Subject: Phase I & III Bond Release, Hiawatha Coal Company, Hiawatha Mine, C/007/0011,
Task ID #5300

Phase I and III Bond Release
Hiawatha Coal Company
Hiawatha Mine
C/007/0011
Carbon County, Utah

PID: C0070011
TaskID: 5300
Mine Name: HIAWATHA MINE
Title: PHASE I & PHASE III BOND RELEASE

12. Backfilling And Grading

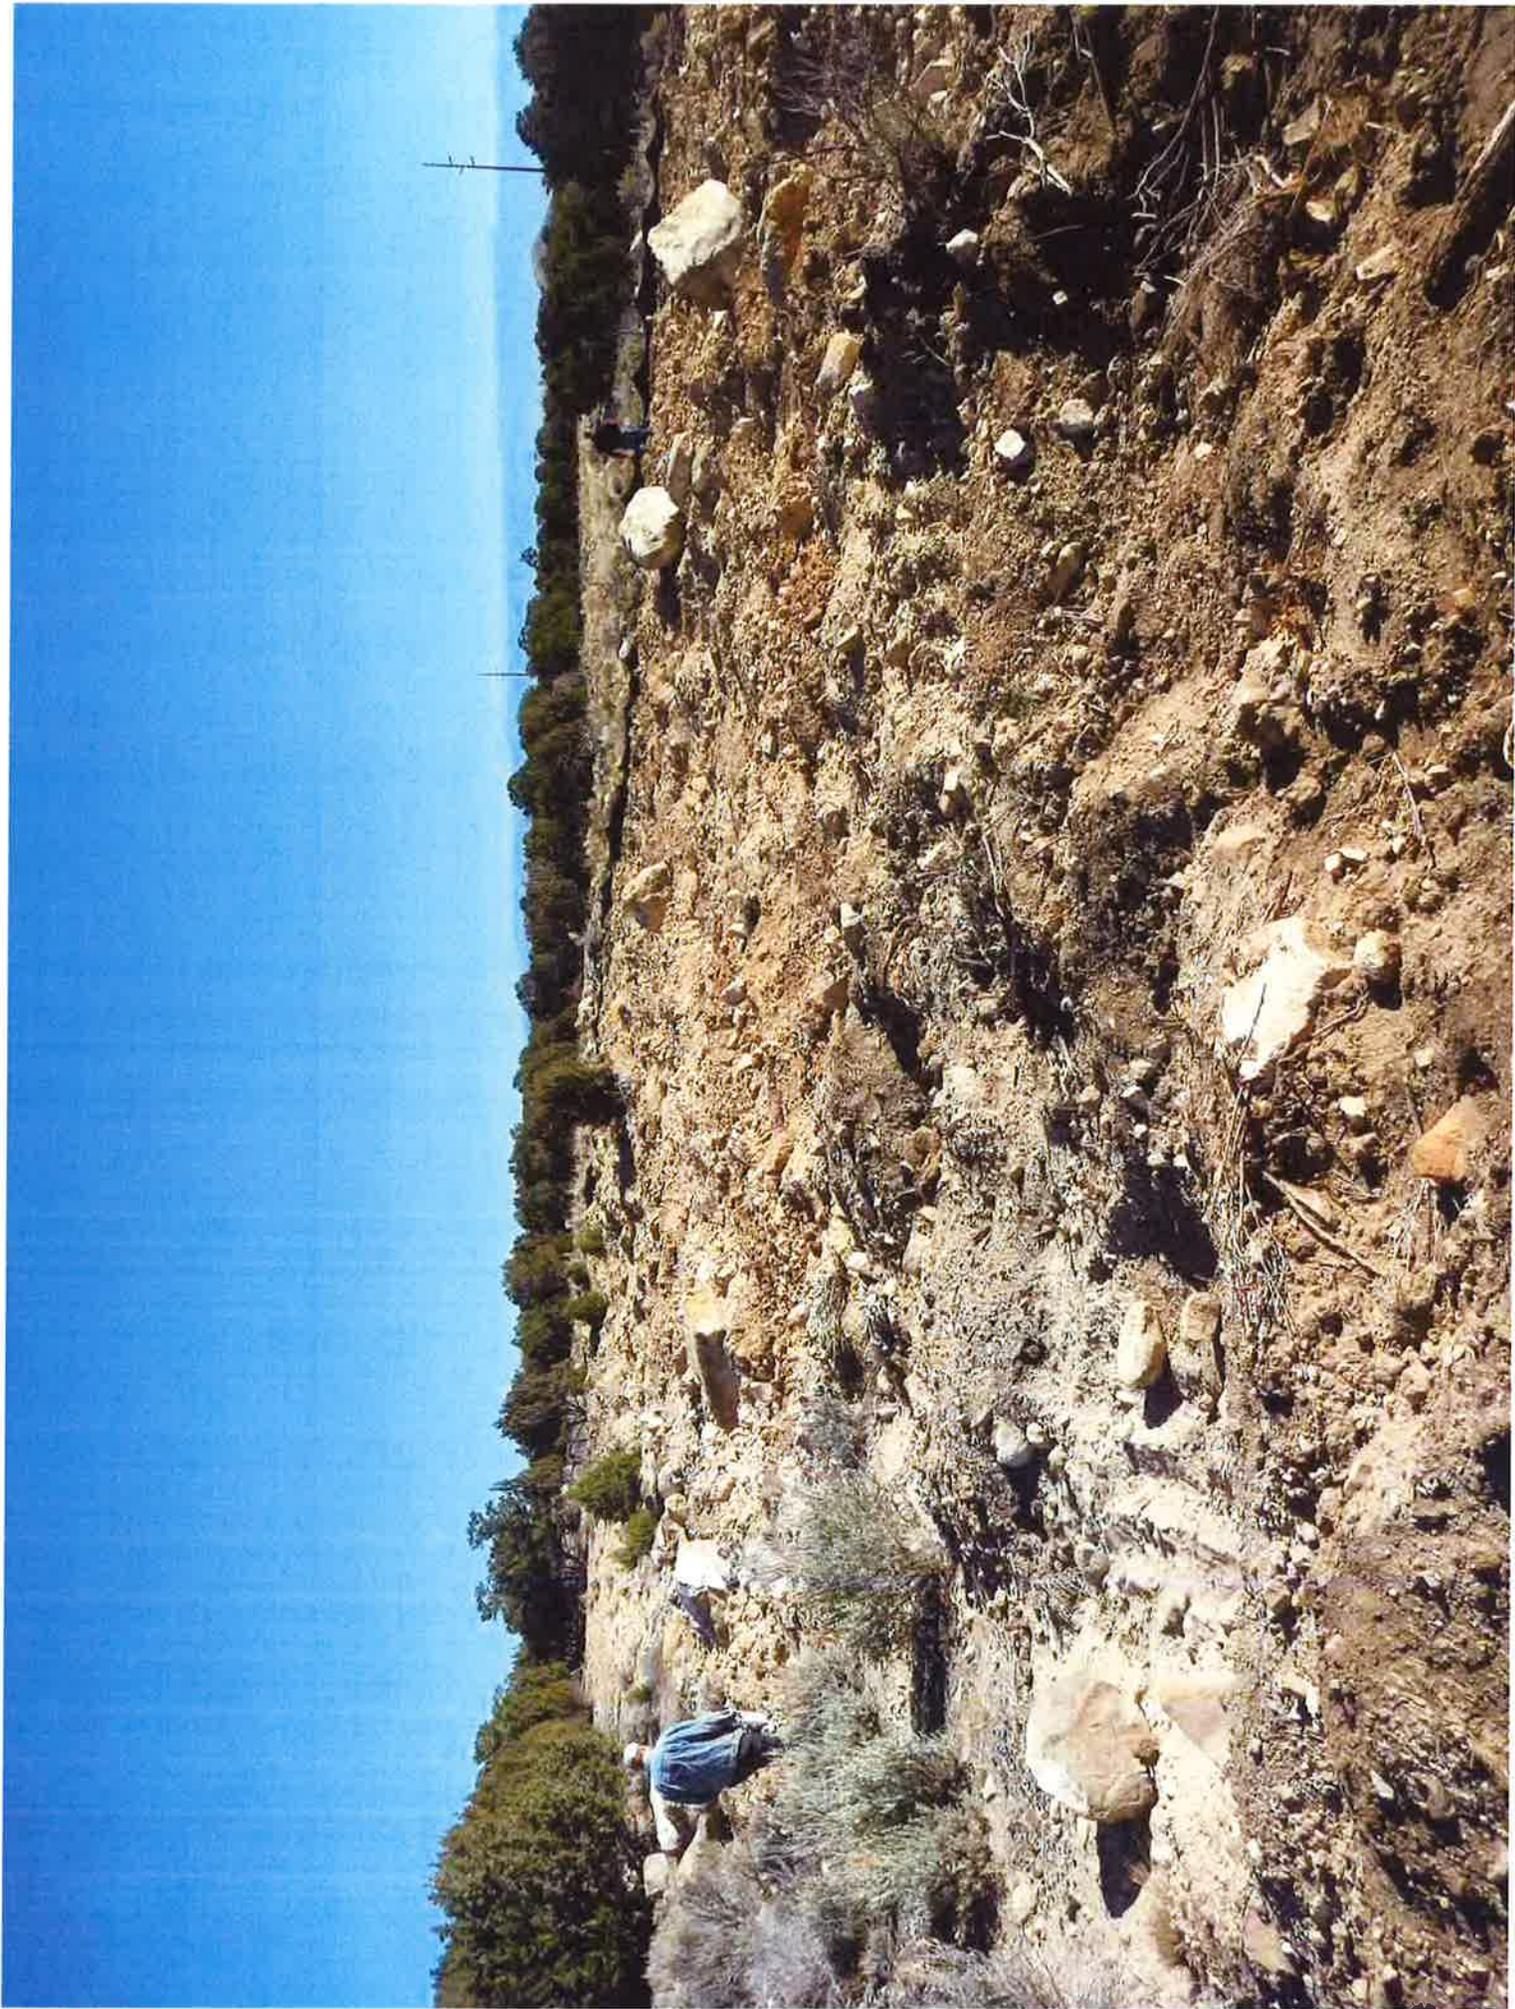
Sediment pond D007 and the connecting diversion ditch, 1.6 acres were backfilled, graded and pocked in September of 2016

13. Revegetation

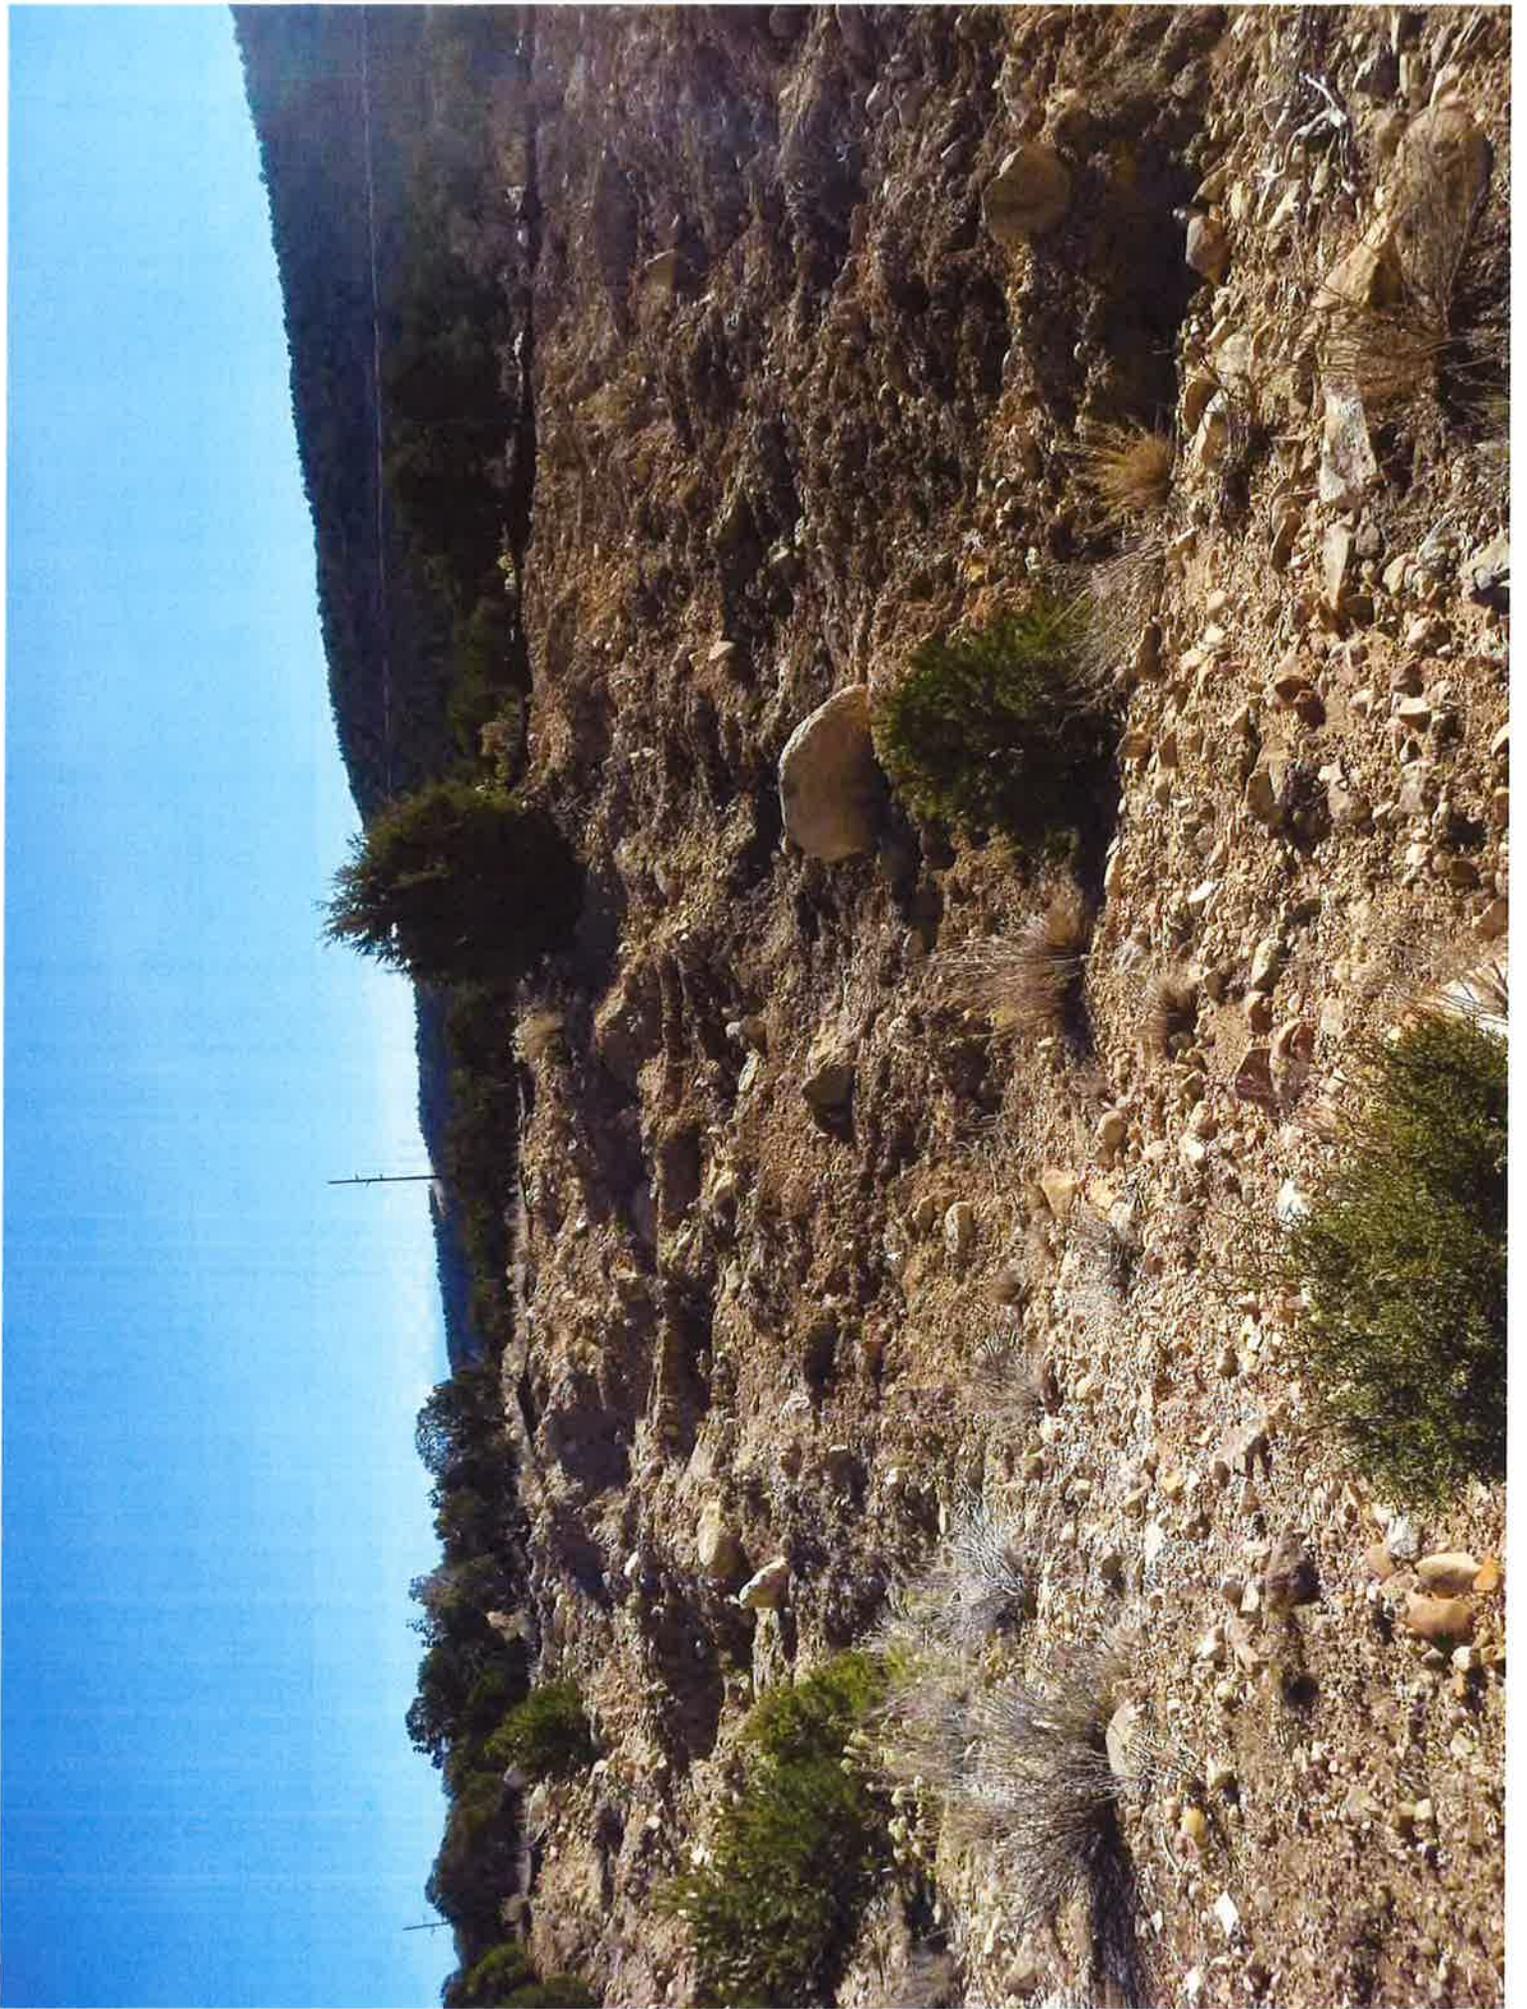
Sediment pond D007 and the connecting diversion ditch, 1.6 acres were seeded in September of 2016. This will begin the 10 year liability period.
